Item 4.9.11 of the provisional agenda

## **Proposal for Supplement 2 to the 03 series of amendments to UN Regulation No. 117 (Tyre rolling resistance, rolling noise and wet grip)**

### **Submitted by the Working Party on Noise and Tyres\***

Figure 1

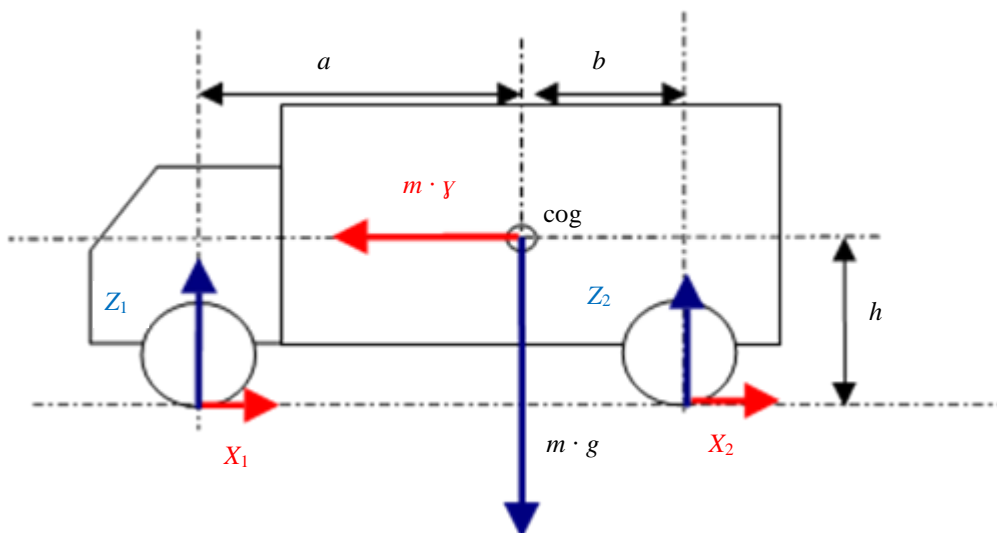
Paragraph 2.2.2.7.5., amend to read:

"2.2.2.7.5. Calculation of the relative wet grip index of the tyre

The wet grip index represents the relative performance of the candidate tyre compared to the reference tyre. The way to obtain it depends on the test configuration as defined in paragraph 2.2.2.2. of this Annex. The wet grip index  $G$  of the tyre is calculated as reported into Table 7:

Where (see also Figure 1):

- $f$ : correction factor depending on used SRTT
- $cog$ : centre of gravity of the loaded vehicle
- $m$ : mass (in kilograms) of the loaded vehicle
- $a$ : horizontal distance between front axle and centre of gravity of the loaded vehicle (m)

- $b$ : horizontal distance between rear axle and centre of gravity of the loaded vehicle
- $h$ : vertical distance between ground level and centre of gravity of the loaded vehicle (m).

- N.B.* When  $h$  is not precisely known, these worst case values shall apply: 1.2 for configuration C2, and 1.5 for configuration C3
- $\gamma$ : loaded vehicle acceleration [ $m \cdot s^{-2}$ ]

- $g$ : acceleration due to the gravity [ $m \cdot s^{-2}$ ]
- $X_1$ : longitudinal (X-direction) reaction of the front tyre on the road
- $X_2$ : longitudinal (X-direction) reaction of the rear tyre on the road

- $Z_1$ : normal (Z-direction) reaction of the front tyre on the road
- $Z_2$ : normal (Z-direction) reaction of the rear tyre on the road

Figure 1

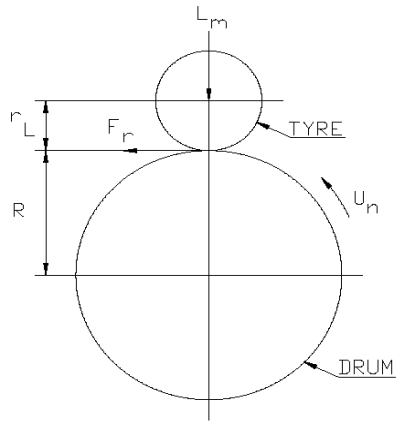
*Paragraph 4.5., amend to read:*

"4.5. Measurement and recording

The following shall be measured and recorded (see Figure 1):

- (a) Test speed  $U_n$ ;
- (b) Load on the tyre normal to the drum surface  $L_m$ ;
- (c) The initial test inflation pressure as defined in paragraph 3.3. above;
- (d) The coefficient of rolling resistance measured  $C_r$ , and its corrected value  $C_{rc}$ , at 25 °C and for a drum diameter of 2 m;
- (e) The distance from the tyre axis to the drum outer surface under steady state  $r_L$ ;
- (f) Ambient temperature  $t_{amb}$ ;
- (g) Test drum radius R;

- (h) Test method chosen;
- (i) Test rim (size and material);
- (j) Tyre size, manufacturer, type, identity number (if one exists), speed category symbol, load index, DOT number (Department of Transportation).
